**STATE OF CONNECTICUT
CONNECTICUT SITING COUNCIL**

Petition No. 1515

**CONNECTICUT GREEN BANK AND CEFIA HOLDINGS, LLC RESPONSES TO THE
JUNE 14, 2022 FIRST SET OF INTERROGATORIES DIRECTED TO CONNECTICUT
GREEN BANK AND CEFIA HOLDINGS LLC MANSON YOUTH CORRECTIONAL
INSTITUTION FROM THE CONNECTICUT SITING COUNCIL**

CTGB - Manson Youth institute

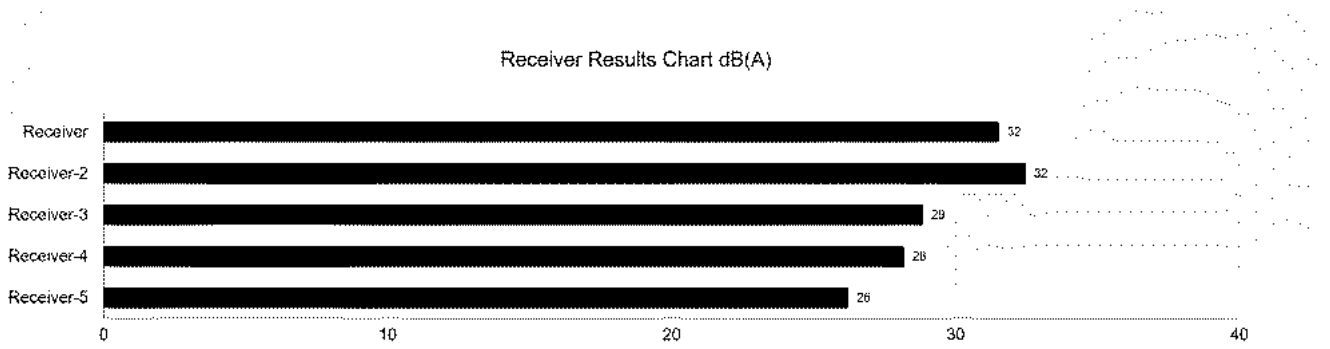
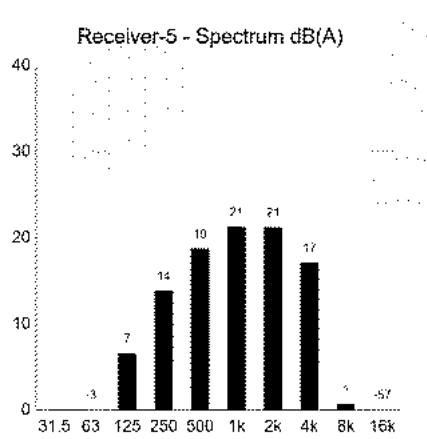
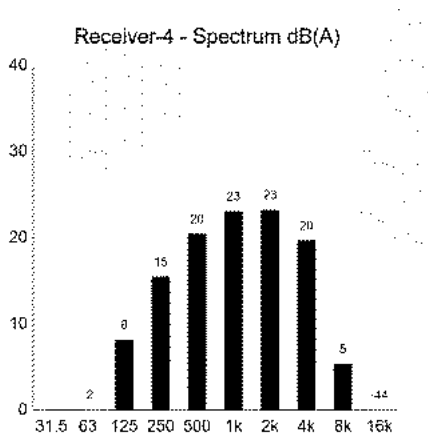
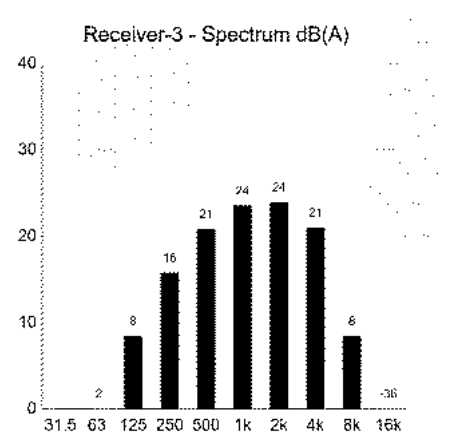
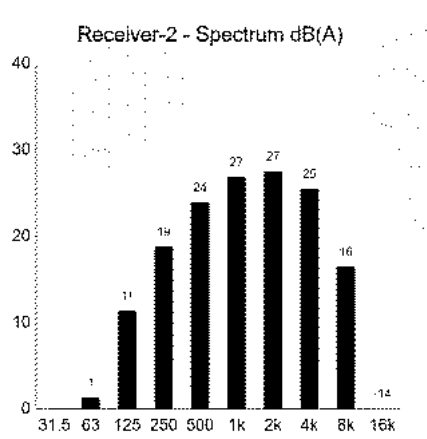
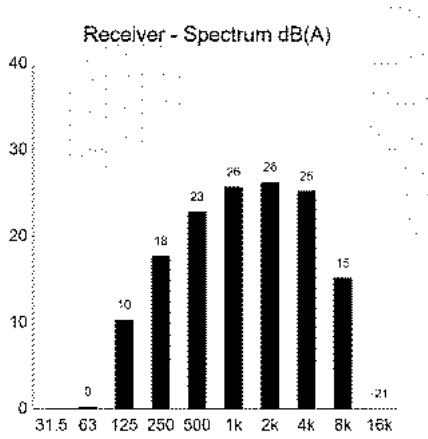
9. Referring to Petition p. 14, submit inverter specification sheets that include inverter operational noise characteristics. Using the inverse square law or other noise analysis method, would operational noise meet applicable DEEP Noise Control Standards at the nearest abutting property line?

- a. Inverter specification sheet included **(Exhibit 2)**. Operational noise limits defined by DEEP Noise Control Standards at the nearest property lines are 55dBA during daytime, 45dBA during evening. Based on noise propagation models created with dbmap.net, inverter noise falls under the limit of 45db well within the boundaries of the property line.**(Exhibit 3)**
